7.7 Control Systems Not Required for Safety

The information in this section of the reference ABWR DCD, including all subsections and figures, as modified by the STP Nuclear Operating Company Application to Amend the Design Certification rule for the U.S. Advanced Boiling Water Reactor (ABWR), "ABWR STP Aircraft Impact Assessment (AIA) Amendment Revision 3," dated September 23, 2010 is incorporated by reference with the following departures and supplements.

Figure 7.7-11 Simplified Functional Diagram of the Automatic Power Regulation System

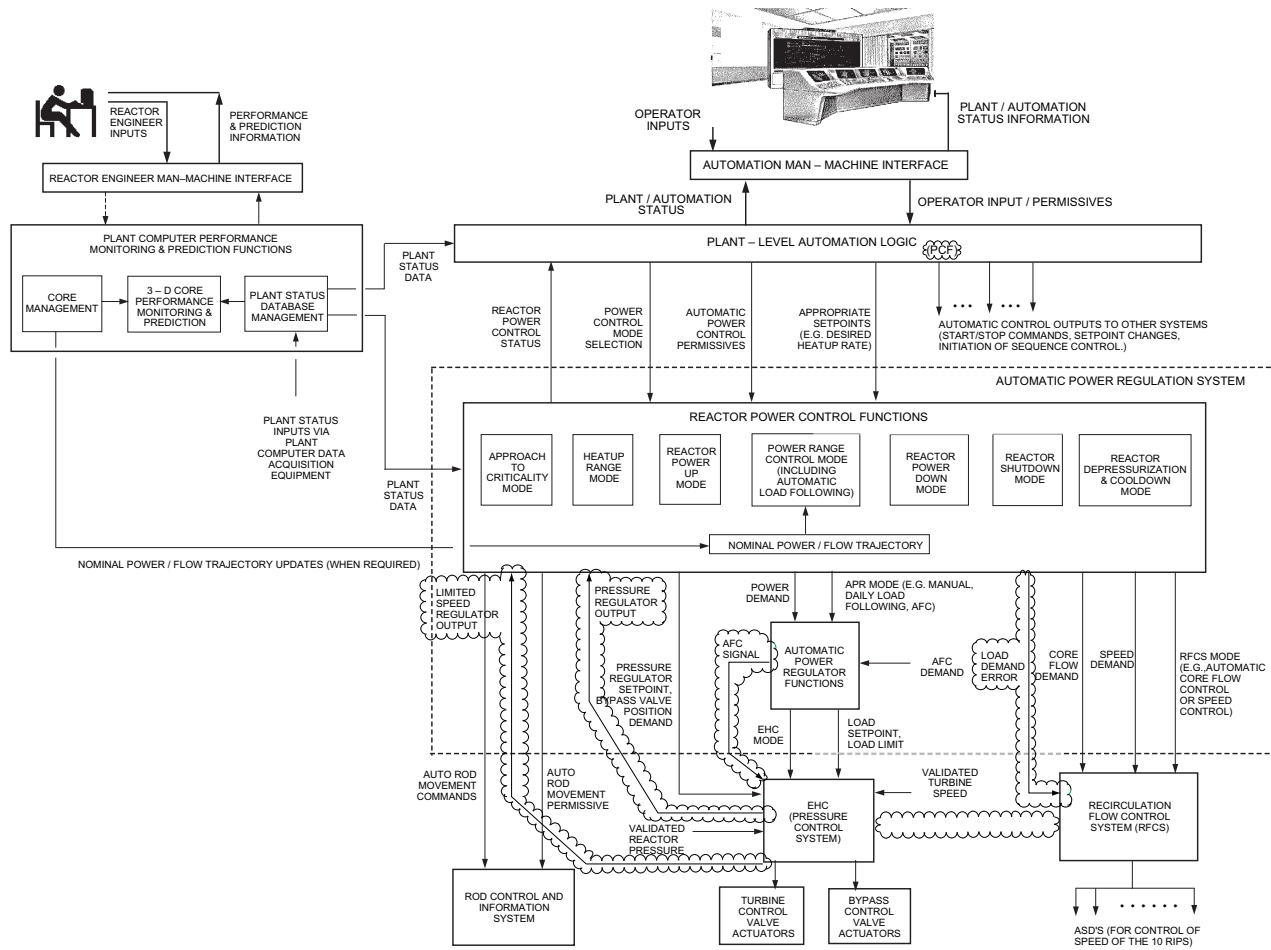
STD DEP 7.7-20 (Figures 7.7-5, 7.7-7, 7.7-11)

STD DEP 7.7-24 (Figures 7.7-11, 7.7-12, 7.7-13)
